PRODUCT/PROCESS CHANGE NOTICE (PCN)

PCN #: **TB1503-01** DATE: **July 22, 2015**
 Product Affected: **TSSOP-20, TSSOP-24, TSSOP-28,**
 TSSOP-48, TSSOP-56, TVSOP-48
 SOIC-28, SSOP-20, SSOP-28,
 (Refer to Attachment II for affected part# shipped in Reel)
 Date Effective: **November 2, 2015 Earliest Date - Refer to**
 specific date by package type

ATTACHMENT I - PCN #: TB1503-01

Detail of Change: This notification is to advise our customers that IDT has planned to standardize the carrier tape on the selective package types to only one type as detailed below.

Illustration of Carrier Tape Pocket Design Change

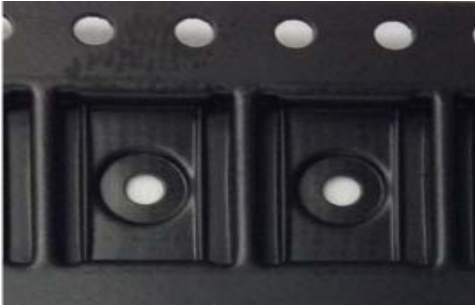
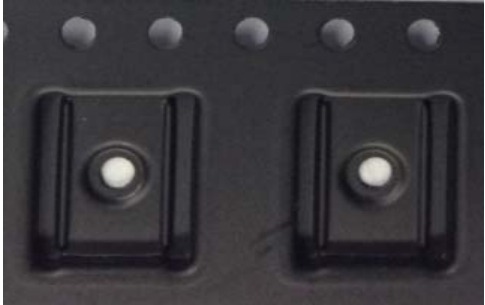
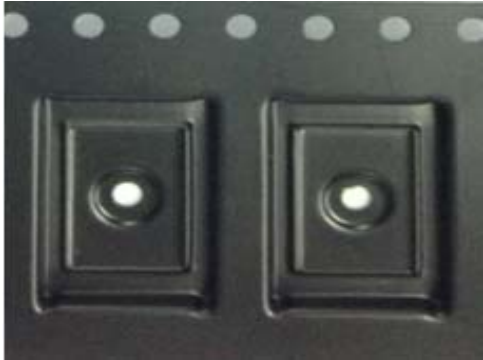
Package	From	To
TSSOP-20	Carrier Tape Part# P8-464-000 	Carrier Tape Part# P8-291-P20 
TSSOP-24	Carrier Tape Part# P8-329-P24 	Carrier Tape Part# P8-169-P24 
TSSOP-48	Carrier Tape Part# P8-260-P48 	Carrier Tape Part# P8-324-P48

Illustration of Carrier Tape Pocket Design Change

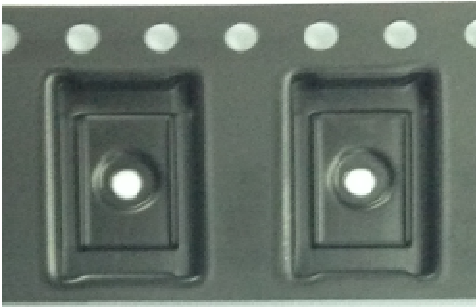
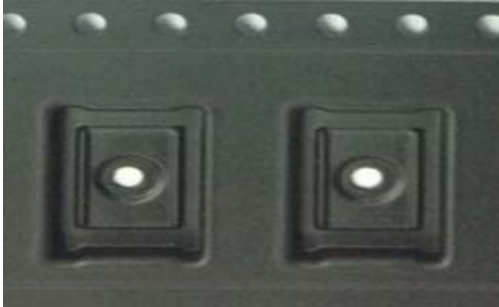
Package	From	To
SOIC-28	Carrier Tape Part# P8-187-S28 	Carrier Tape Part# P8-370-P28 
TSSOP-28 and TVSOP- 48	Carrier Tape Part# P8-145-PF8 	Carrier Tape Part# P8-330-P48 
TSSOP-56	Carrier Tape Part# P8-261-P56 	Carrier Tape Part# P8-314-P56

Illustration of Carrier Tape Pocket Design Change

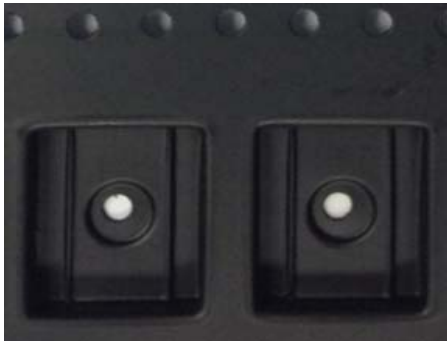
Package	From	To
SSOP-20	Carrier Tape Part# P8-259-P20 	Carrier Tape Part# P8-320-P20 
SSOP-28	Carrier Tape Part# P8-384-P28 	Carrier Tape Part# P8-321-P28
